Assessment of erosion, sedimentation, and water quality impacts of the Mountain Valley Pipeline and Equitrans Expansion Project's proposed crossing of the Jefferson National Forest as it pertains to the U.S. Forest Service's Draft Supplemental Environmental Impact Statement dated December 2022

February 9, 2023

Prepared by Jonathan A. Czuba, Ph.D., Licensed Professional Engineer

Prepared for The Wilderness Society

Figure 1. Land-surface slopes around the MVP in the JNF. Note the MVP crosses the JNF in two locations: Peters Mountain and Brush Mountain.

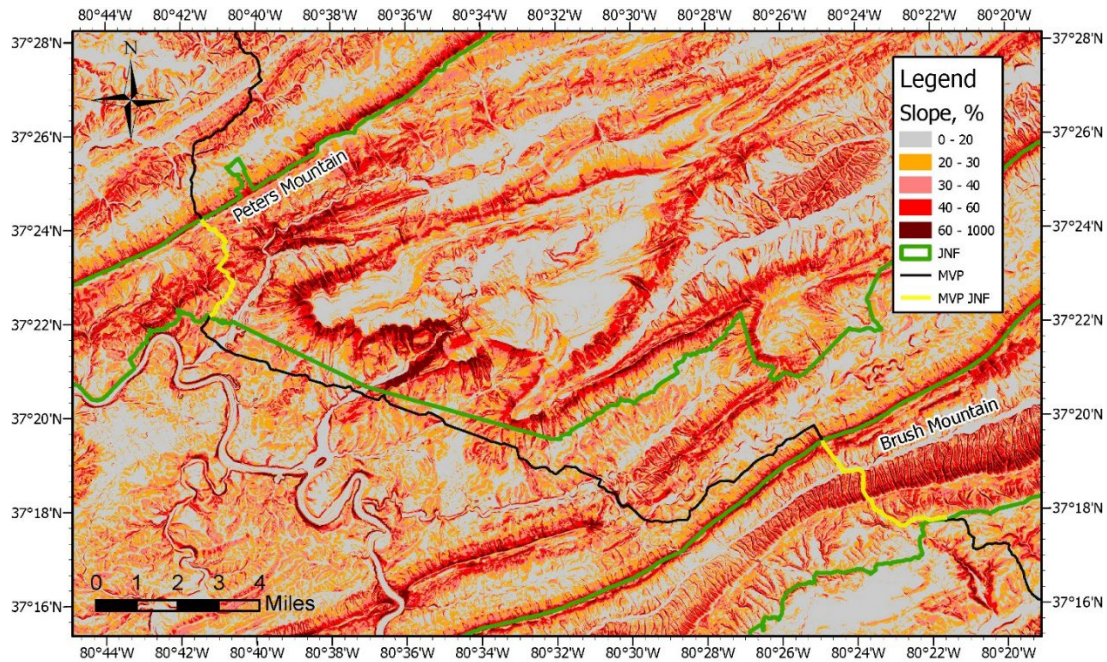
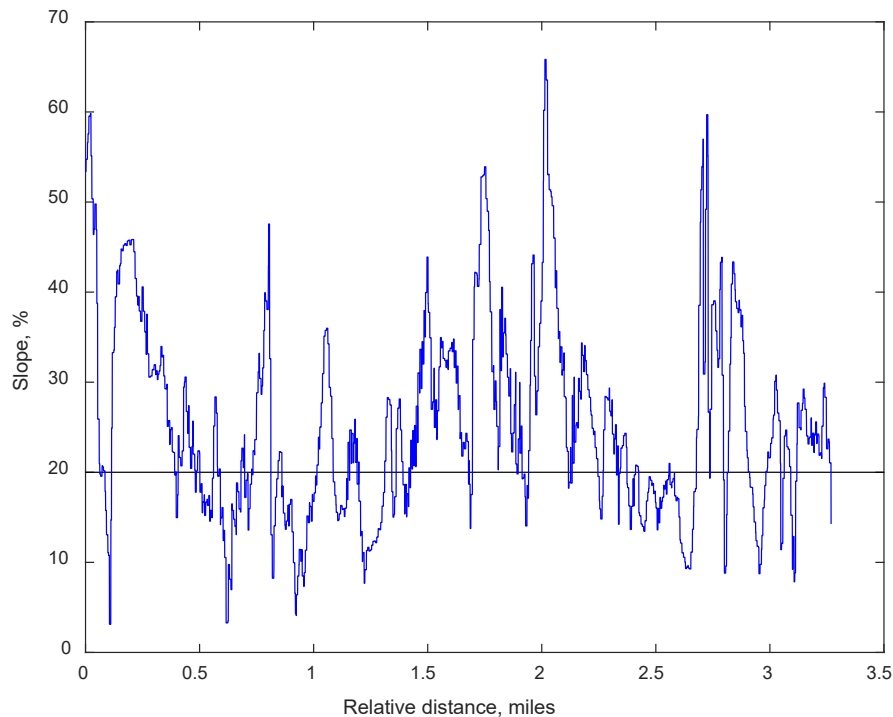
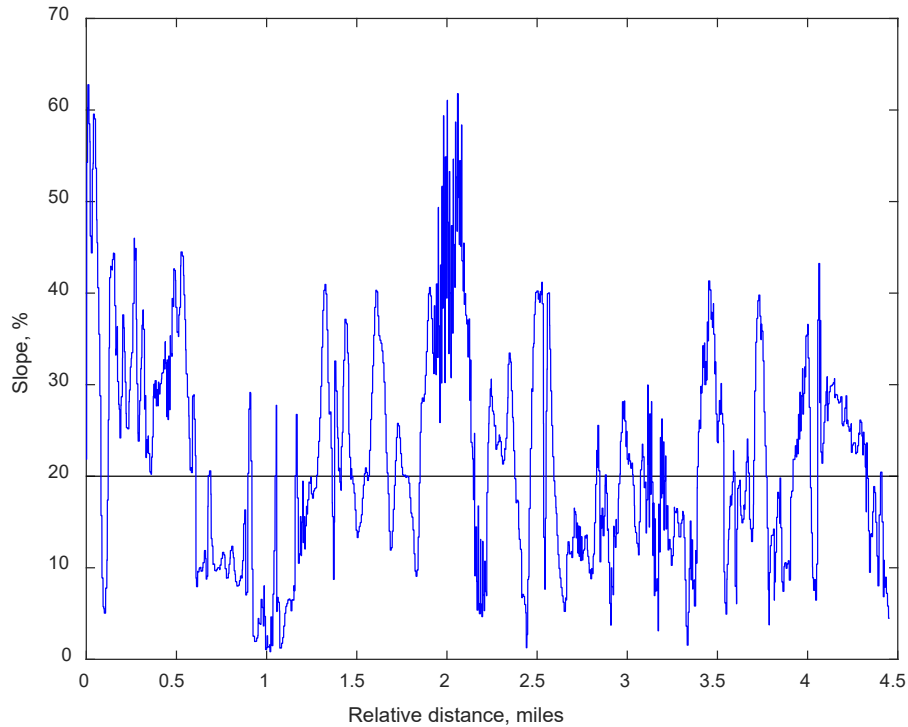
An analysis of the slopes along the MVP pathway through the JNF illustrate that slopes above 20% are common. Slope was calculated as a percent (vertical distance divided by horizontal distance multiplied by 100) based on a 10-meter DEM using the Surface Parameters tool in ArcGIS Pro. The 10-meter DEM is the same dataset at the same resolution as was used in the RUSLE2 modeling (p. 27, Geosyntec, 2020; USGS, 2023). A spatial map of slope in the vicinity of the MVP crossing of the JNF is shown in Figure 1. There are two separate crossings of the MVP in the JNF. One crossing farthest to the northwest crosses Peters Mountain and the second crossing farthest to the southeast crosses Brush Mountain. The slope of the land surface along the MVP crossing was extracted every 3.28 feet (1 meter) for both crossings and are shown in Figures 2 and 3.

The percentage of length, relative to the total length, of the MVP crossing of the JNF with slopes above certain values are summarized in Table 2 for both crossings and combined. Over 60% of the length of the MVP crossing of the JNF at Peters Mountain has a slope >20% and nearly 30% of the length has a slope >30% (Table 2). At Brush Mountain, over 50% of the length of the MVP crossing of the JNF has a slope >20% and over 20% of the length has a slope >30%. Combining both locations, nearly 57% of the total length of the MVP crossing of the JNF has a slope >20% and 26% of the total length has a slope >30% (Table 2). **This means that the RUSLE/RUSLE2 model is most applicable to only 43% of the MVP study area in the JNF (where slope is < 20%) and there is very limited data (in deriving the fundamental RUSLE/RUSLE2 model equations) to support the validity of the RUSLE/RUSLE2 model results obtained from 26% of the MVP study area in the JNF (where slope is > 30%).**

Figure 4. Turbidity measured at the paired USGS gages on the Roanoke River between 15 and 18 July 2019.

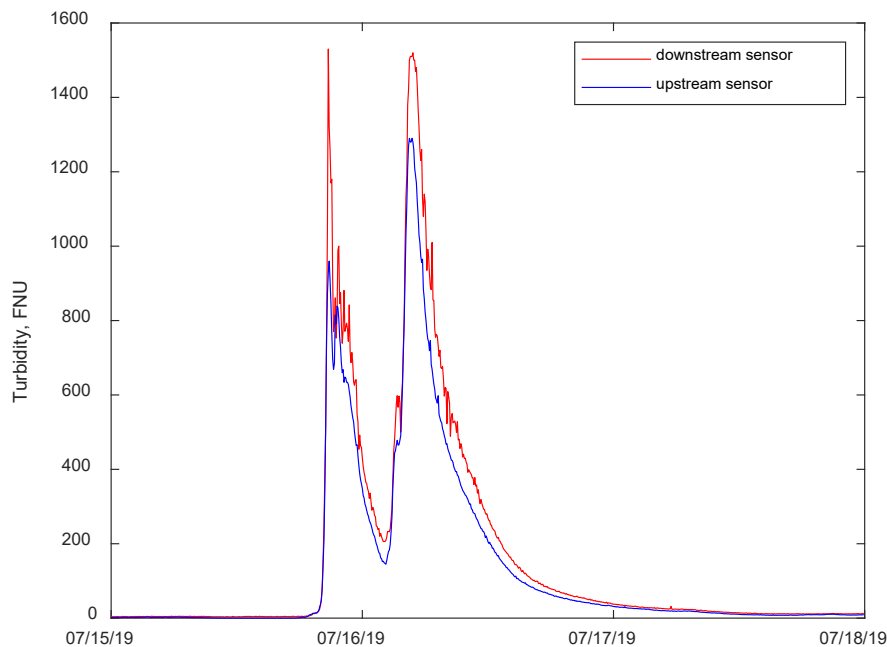
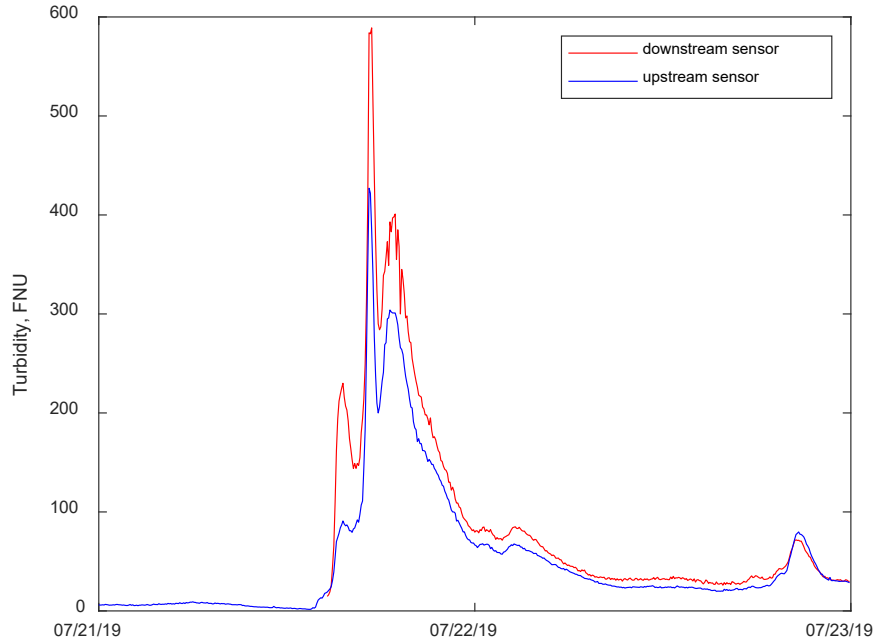
However, that does not preclude gaining some insight about some of the changes that were observed. The largest changes in water quality are expected to occur during construction (July 2019, p. 41, Table 4, DSEIS, 2022; although pollution incidents began in 2018 upstream in the watershed, see section 5). The turbidity measurements for the first few major storm events in July 2019, during construction are shown in Figure 4 and 5.

The peak turbidity values for each of these two storm events are shown in Table 3 along with the percent increase in turbidity from the upstream sensor to the downstream sensor. The first peak of each storm event exhibited the greatest increase from the upstream sensor to the downstream sensor of 60% and 150% for the first and second storm events, respectively. The later peaks of each storm event exhibited a 20% to 40% increase in turbidity from the upstream sensor to the downstream sensor (values from the table were rounded in the text for clarity). This shows that the turbidity in the Roanoke River has increased quite considerably downstream of the MVP crossing. These percentages could be compared to RUSLE2 modeling results, in general if the model was applicable to the landscape (see section 2.1), to assess if percent changes are in reasonable agreement.

The analysis of these two storm events on the Roanoke River (Table 3) indicates that **turbidity has increased by 20% to 150% during construction in contrast to the 0.1% to 2.6% increase in sediment yield suggested by the RUSLE2 modeling. This is a substantial difference that further underscores the poor applicability of the RUSLE2 modeling and suggests that predicted water quality impacts are being severely underestimated.** Going from a 2% increase in sediment predicted by RUSLE2 to a 20% or 150% increase in sediment indicated by the monitoring data represents an **underprediction of between one and two orders of magnitude.** This increase of 20% to 150% is likely an underestimate because, as noted above, the upstream sensor may be reporting an already elevated turbidity reading because of the potentially more extensive construction work farther upstream in the watershed (see also section 5). This change in turbidity was observed after the enhanced BMPs (erosion control devices) were in place.

Figure 6. Turbidity measured at the paired USGS gages on Little Stony Creek for a 6-hour period between 10:00 PM on 21 August 2022 and 4:00 AM on 22 August 2022.

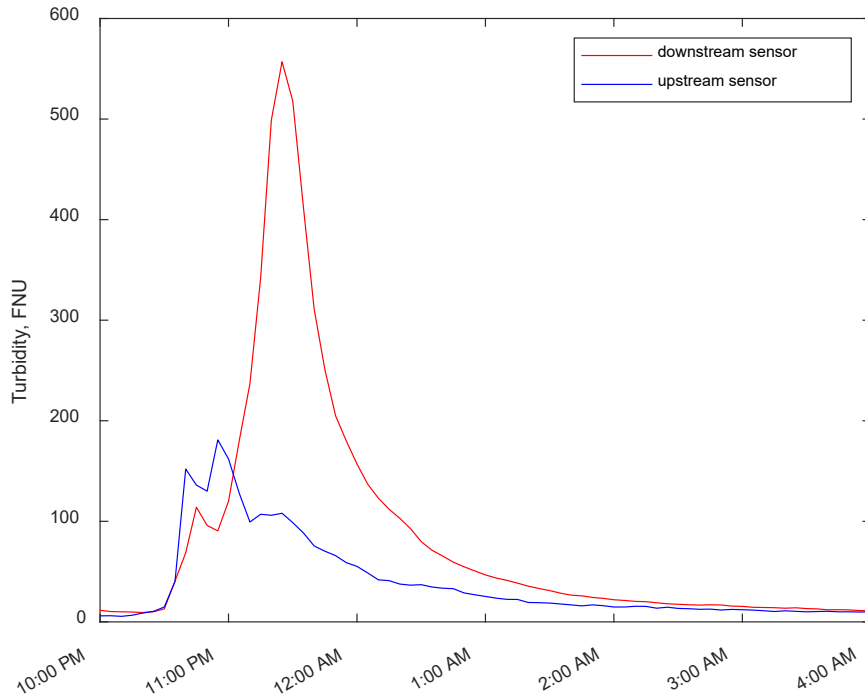
According to the 2022 DSEIS (p. 41, Table 4), construction started in September 2021 in the Little Stony Creek watershed (although pollution incidents began in June 2021, see section 5). The storm event that generated the largest turbidity readings at both the upstream and downstream sensors since construction started occurred overnight between 21 and 22 August 2022 (Figure 6). A peak turbidity of 181 FNU was recorded at the upstream sensor and 557 FNU at the downstream sensor. This corresponded to more than a 200% increase in turbidity from the upstream sensor to the downstream sensor.

in there being very few flow events generating turbidity that can be analyzed. However, this single event shows that **peak turbidity has increased by 200% after construction in contrast to the 0.1% to 2.6% increase in sediment yield suggested by the RUSLE2 modeling**. This is a substantial difference that further underscores the poor applicability of the RUSLE2 modeling and suggests that predicted water quality impacts are being severely underestimated. Going from a 2% increase in sediment predicted by RUSLE2 to a 200% increase in sediment indicated by the monitoring data represents an **underprediction of two orders of magnitude**.
